ADDENDUM NO. 02

PROJECT: IRVINE UNIFIED SCHOOL DISTRICT
Bid No. 23/24-04MO, Deferred Maintenance: HVAC Equipment Replacement Project at Rancho San Joaquin Middle School

ADDENDUM NO. 2

Rancho San Joaquin MS HVAC Replacement

A1-3.0

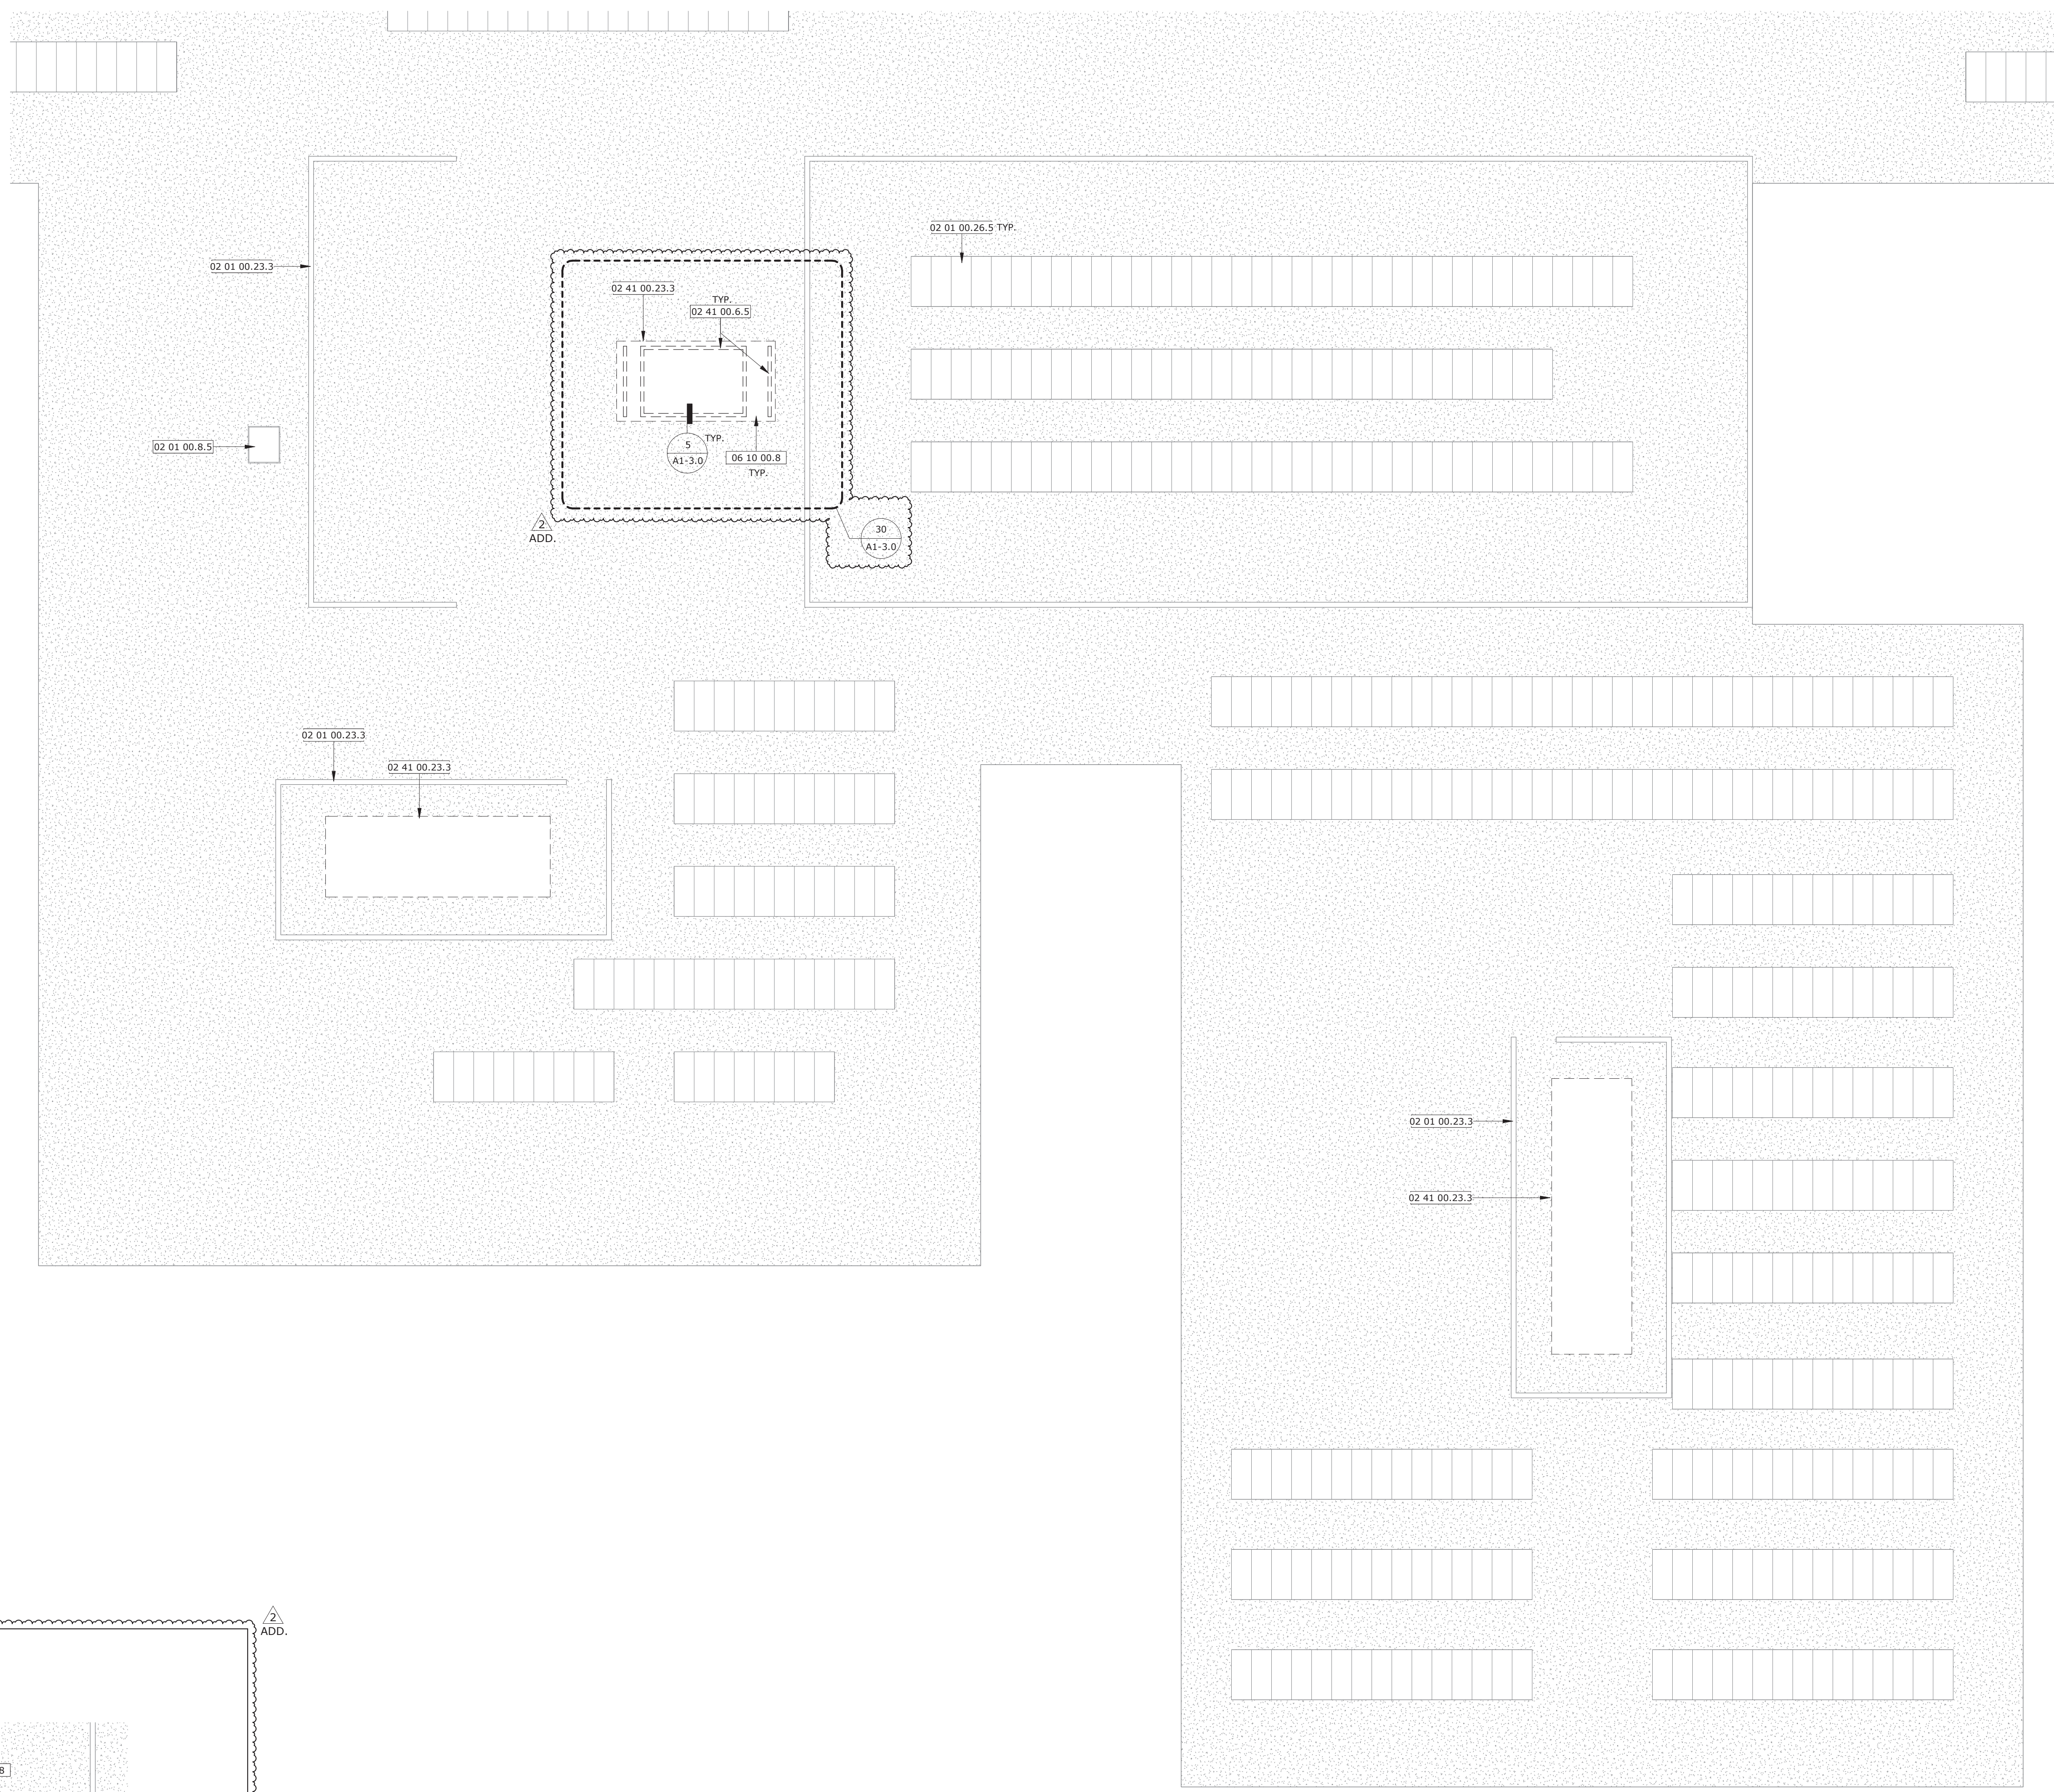
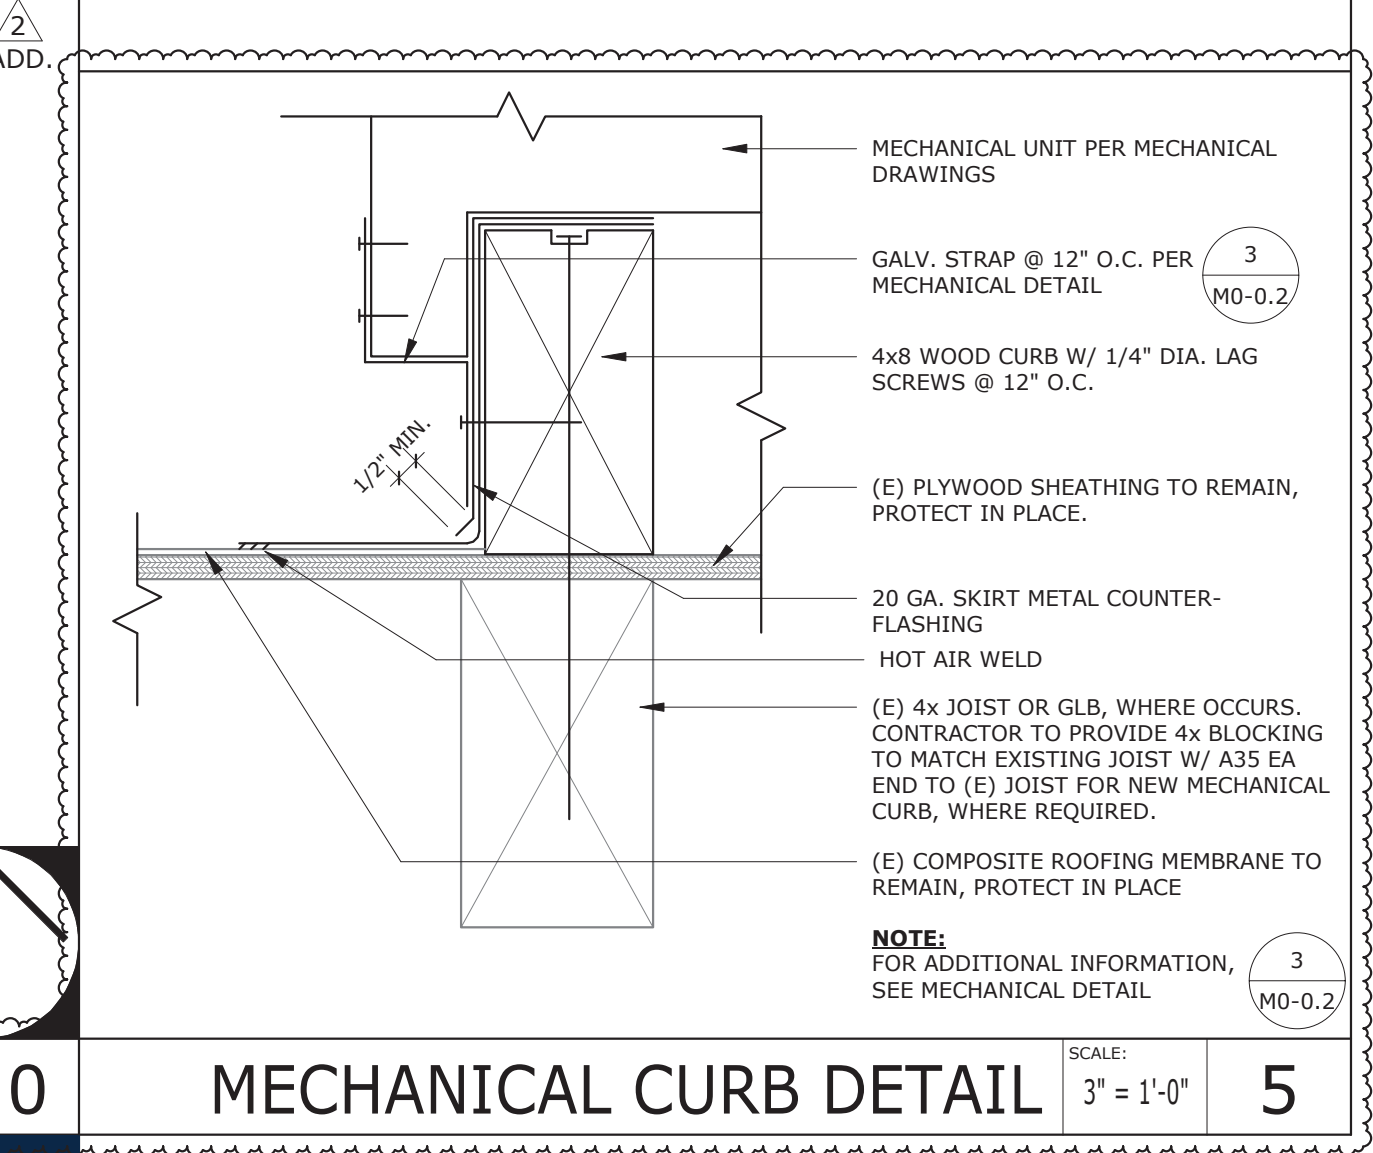
1. Discard sheet A1-3.0 – Roof Plan previously issued and replace with Delta #2 sheet A1-3.0 – Roof Plan, dated 04/30/2024.
2. Sheet M0-0.2 – Mechanical Schedules and Details: Add detail 3 for addition of new curbs at unit AC-A1 MPR per attached Sketch MSK-2.1.
3. Sheet M1-2.0 – HVAC Demolition Plan: Revise demolition plan per clouded areas of attached Sketch MSK-2.2.
4. Sheet M1-3.0 – HVAC Roof Plan – Bldg A1, A2 and B: Add new curbs at AC-A1 MPR per clouded areas of attached Sketch MSK-2.3.
5. Sheet M1-3.0 – HVAC Roof Plan – Bldg A1, A2 and B: Add rerouting of existing gas piping around AC-A1 MPR per attached Sketch MSK-2.3.

| 2.2.1 | Replace Sheet A1-3.0 in its entirety per clouded areas listed below and on attached Sheet A1-3.0:

a. Add Detail 5, Mechanical Curb Detail for new curb per clouded areas attached.
b. Revise Roof Plan to show demolition of existing mechanical curb per clouded areas attached.

c. Add Detail 30 Enlarged Roof Plan for new curb per clouded areas attached. |

Description: **M1-2.0 - HVAC DEMOLITION PLAN**

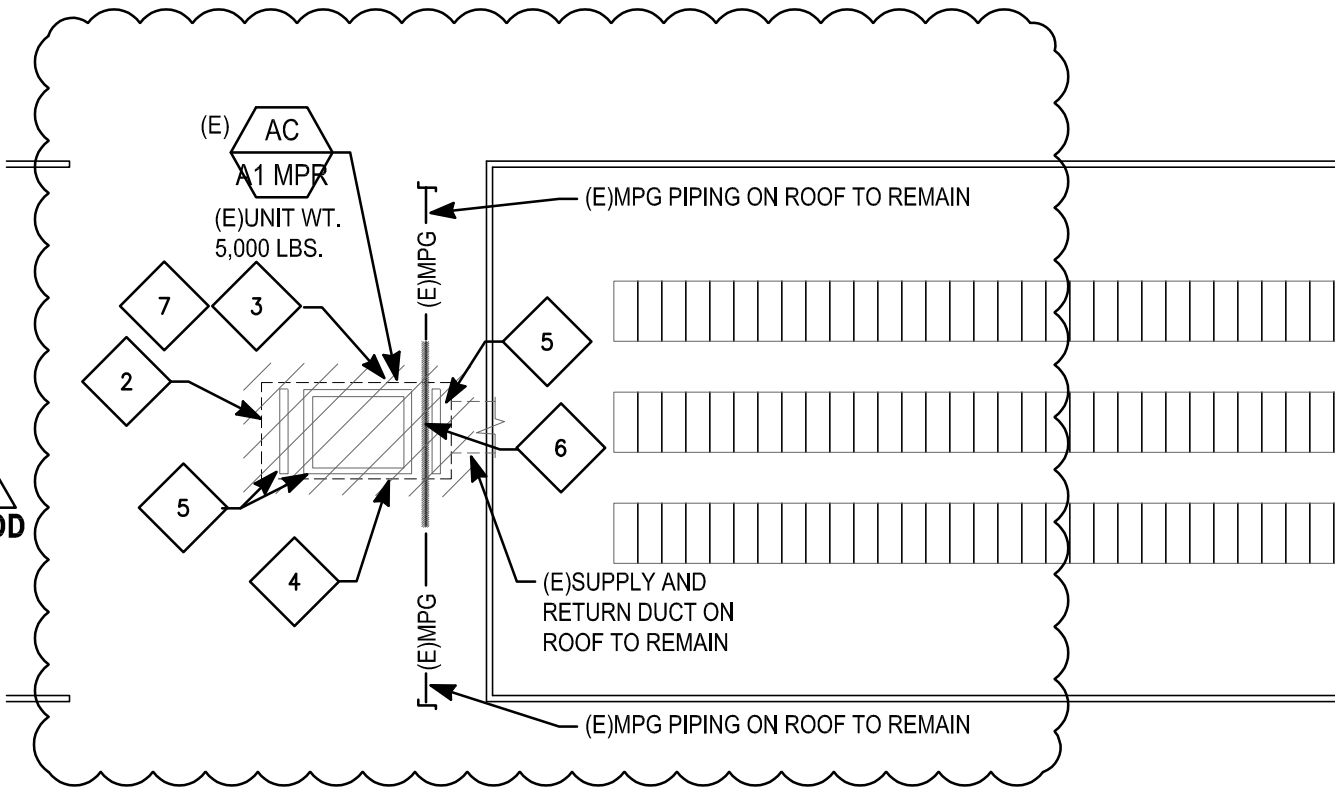
5 CAREFULLY DEMOLISH EXISTING CURB(S) TO BE REMOVED AND REPLACED WITH NEW SINGLE CURB.

6 DEMOLISH EXISTING 2"MPG ROUTED ON ROOF BELOW UNIT BETWEEN EXISTING CURBS. MPG TO BE REROUTED.

7 DEMOLISH EXISTING CONDENSATE PIPING ROUTED BELOW UNIT

| 2.3.1 | Revise demolition plan per clouded areas of attached Sketch MSK-2.2. |

M1-3.0 - HVAC ROOF PLAN BLDG. A1

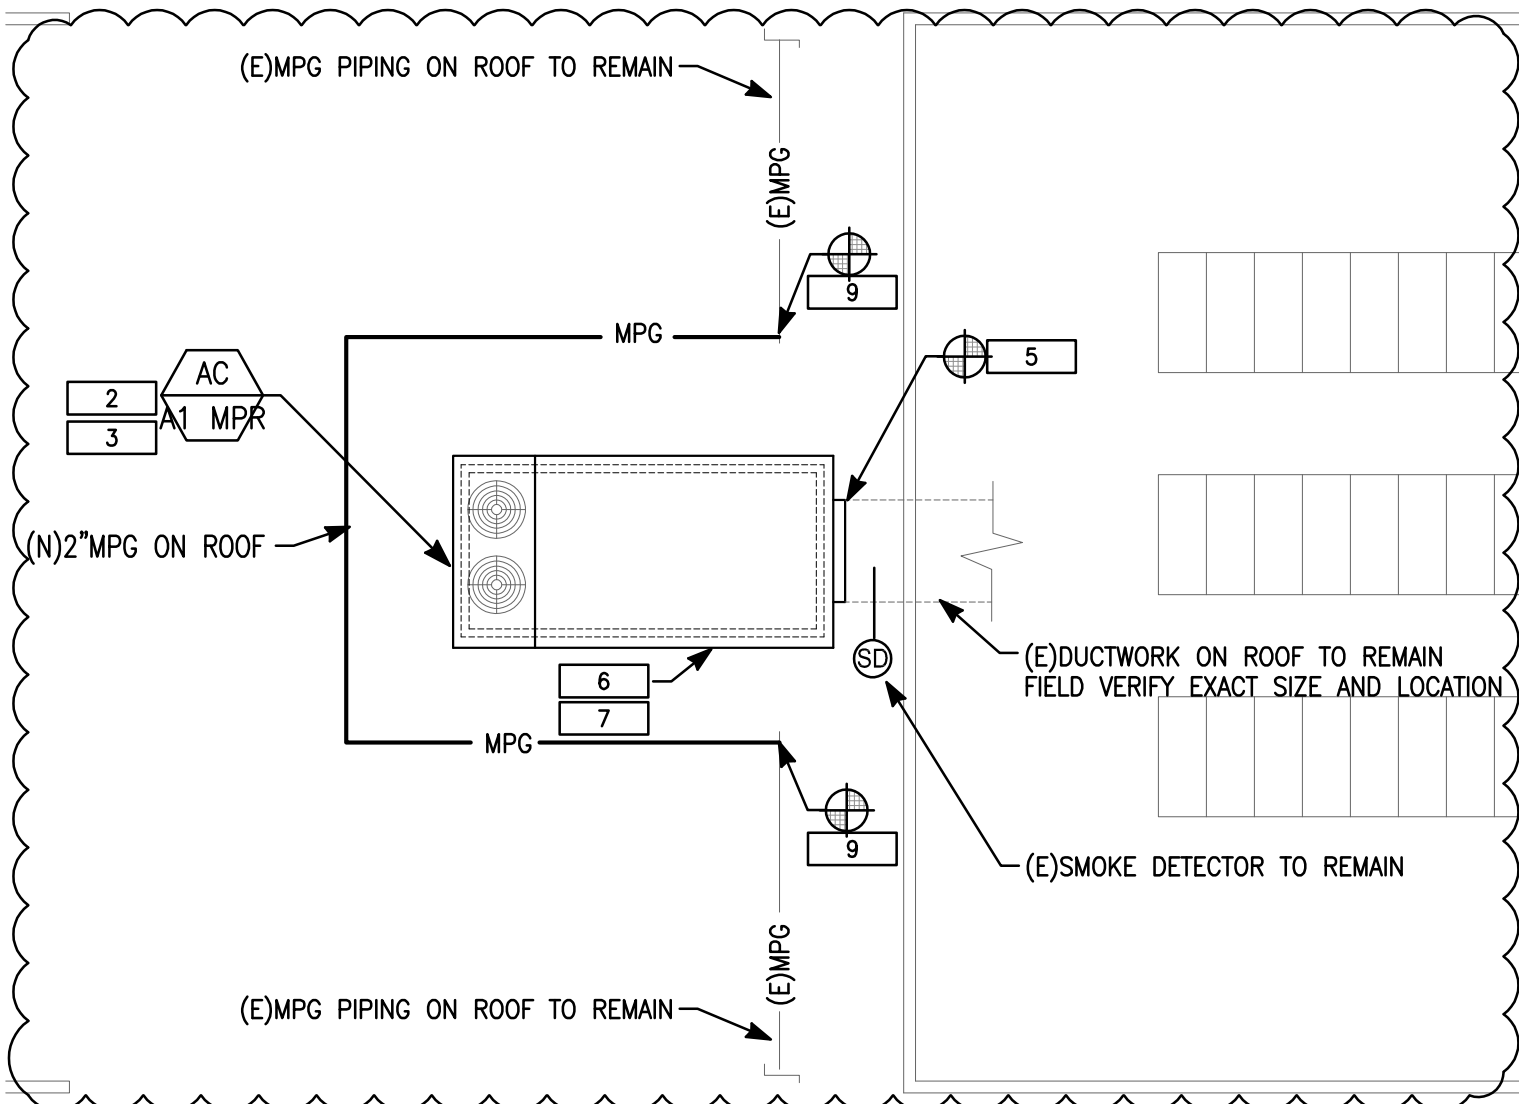
2 INSTALL NEW HORIZONTAL AIR CONDITIONING UNIT AND NEW CURB ON ROOF. SEE DETAILS

9 POC 2"MPG TO (E)2"MPG ON ROOF. FIELD VERIFY EXACT LOCATION AND SIZE. ROUTE & OFFSET NEW PIPING TO AVOID ANY EXISTING OBSTACLES.

| 2.4.1 | Add new curbs at AC-A1 MPR per clouded areas of attached Sketch MSK-2.2. |
| 2.4.2 | Add rerouting of existing gas piping around AC-A1 MPR per attached Sketch MSK-2.2. |
